REMARKS

Appin. No. 09/869,613 Response to Office Action dated: August 23, 2004 Annotated Drawing Sheet Showing Changes . O 00/41086 -PCT/FR99/03312-FEB 2 3 2005 HADEMA 1/4 Fig. 1 6 3 8-bit I2C bus 12 decoder ens 2 wires DUS IZC. To bitsmemory unit Micro.C PIC 16C5X BUS 12C 12C -8 bits 8 Bits 22, 23 BUS 12C 10 2 wires clid 8 11 8 bit izc Fig. 2 decoder 8- bit I2C bus decader 20 13 Low battery Screen Contrast 9 8 BACK RETOUR 18 15 PRINTER PAGE **IMPRIMANTE** 14 16 **VALID** 0 CODICIL® 17 19

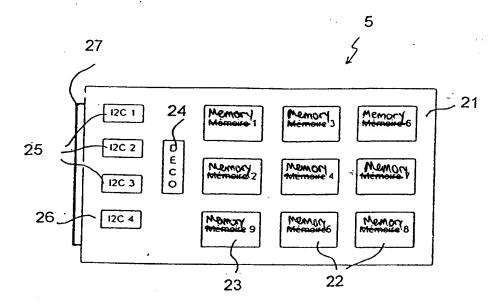
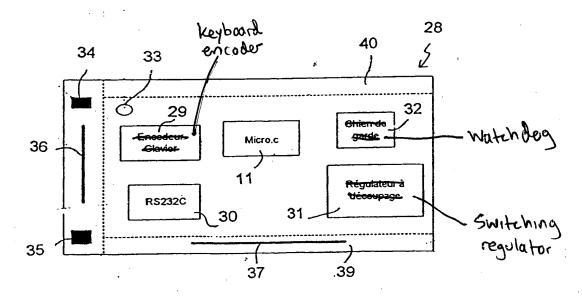
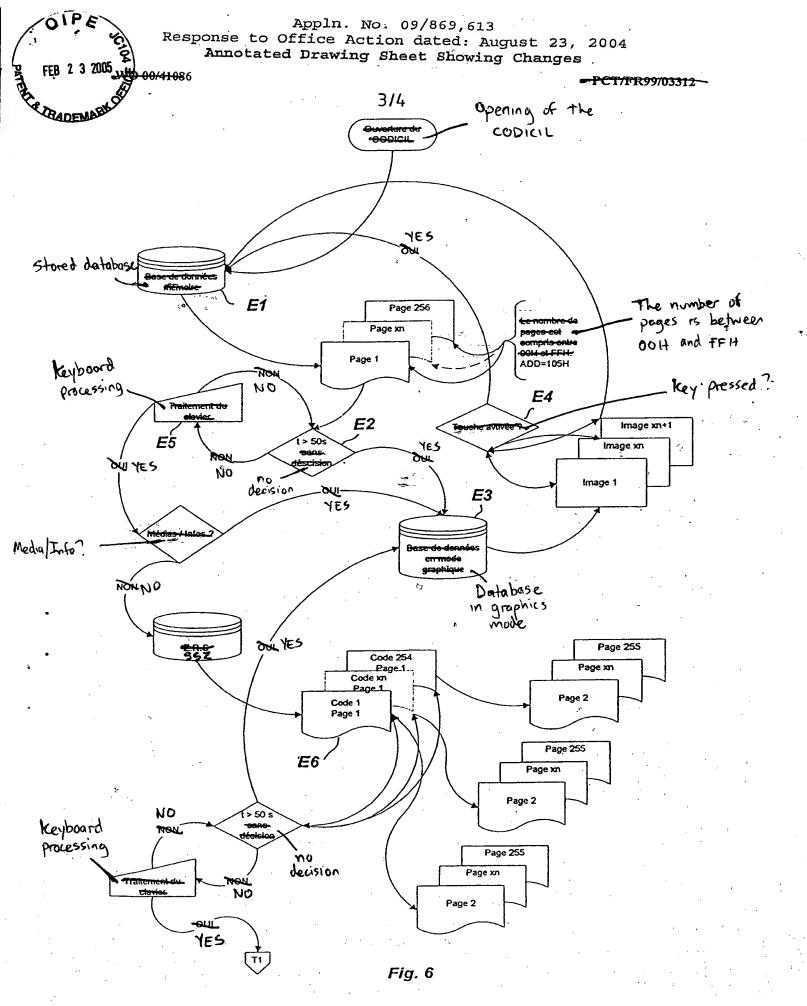
The drawings were objected to because the drawing elements were not labeled in English. Substitute drawings are attached herewith which provide the labels in English. Withdrawal of this objection is respectfully requested.

The drawings were also objected to because the reference character "25" had allegedly been used to designate both I2C buses and 8-bit decoder components as claimed in claim 5. It is noted that the bus 10 is an "I2C" bus developed by Phillips (see page 5, lines 17-18 of the description), and not "12C" as mentioned in the Office Action. Applicant has amended claim 5 to clarify that the three eight-bit decoder components 25 are actually bus decoders for bus I2C (see for example page 7, lines 16-20 of the description). Accordingly, claim 5 now recites three eight-bit I2C bus decoder components 25. Withdrawal of this objection is respectfully requested.

Attached to this paper are replacement drawings for Figs. 3-7 as well as annotated sheets showing changes to the original drawings.
